Your refs: PPA/23/00004 &  
23/04191/REM

20 May 2024

## 23/04191/REM RESERVED MATTERS - RESIDENTIAL DEVELOPMENT: LAND NORTH OF WORTS' CAUSEWAY, CAMBRIDGE (SITE GB1) – AMENDED PLANS AND ADDITIONAL SUPPORTING INFORMATION

Figure 2 Extract from Cambridge Housing Estate Road Construction Specification

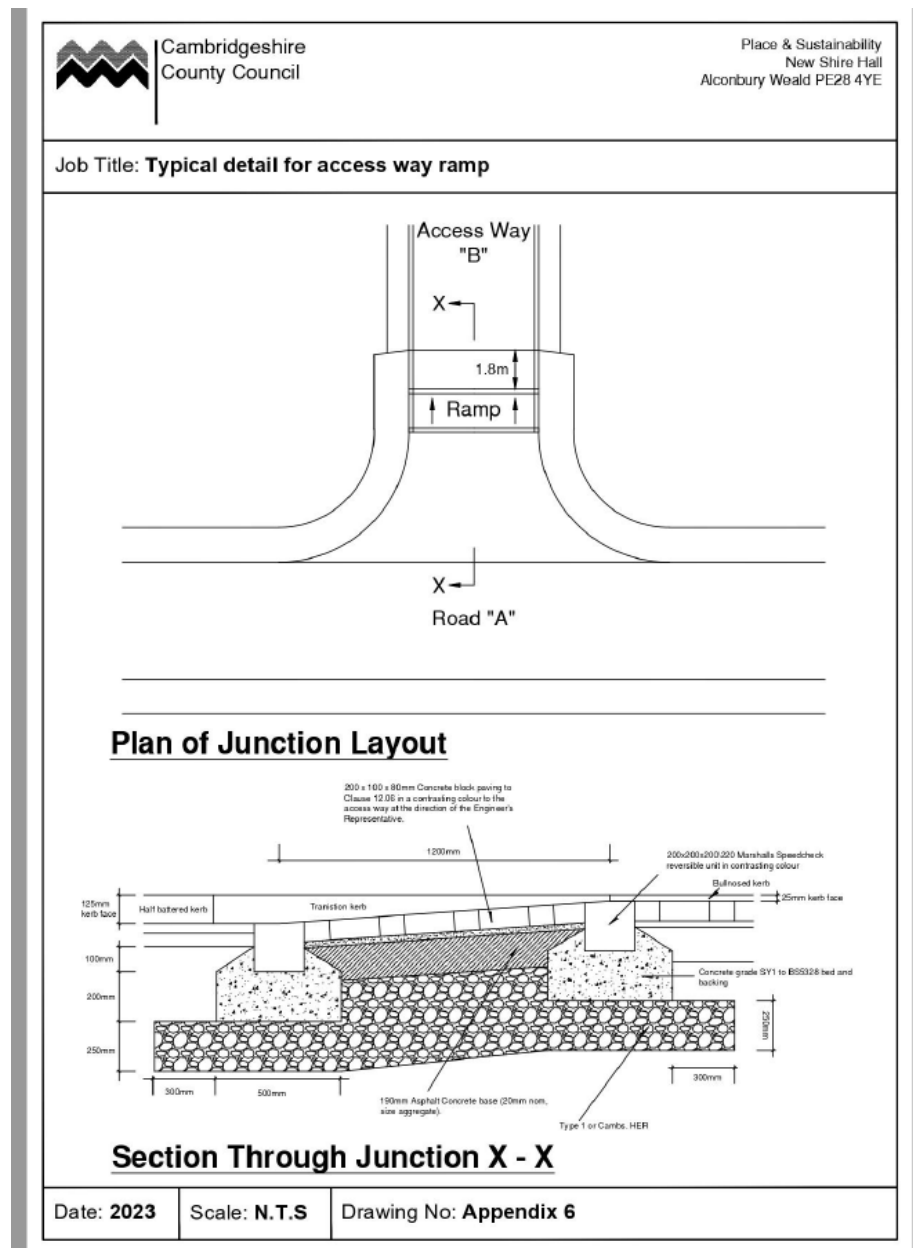
Review ramps/road tables for cyclists to stay on flat surface

The proposed layout benefits from an extensive network of cycle paths that are level and do not require cyclists to negotiate ramps. Most of the development is accessible via the cycle/footways or shared surfaces, so the provision of ramps on the road should not be of a concern.

That said LTN1/20 states that traffic calming techniques can be used to help reduce vehicle speed and volumes to make cycling in mixed traffic less hazardous and more comfortable.

Ramps are to be constructed in accordance with the Cambridge Housing Estate Road Construction Specification, extract below. These incorporate a slight gradient (typically 1 in 12). A typical detail is provided below.
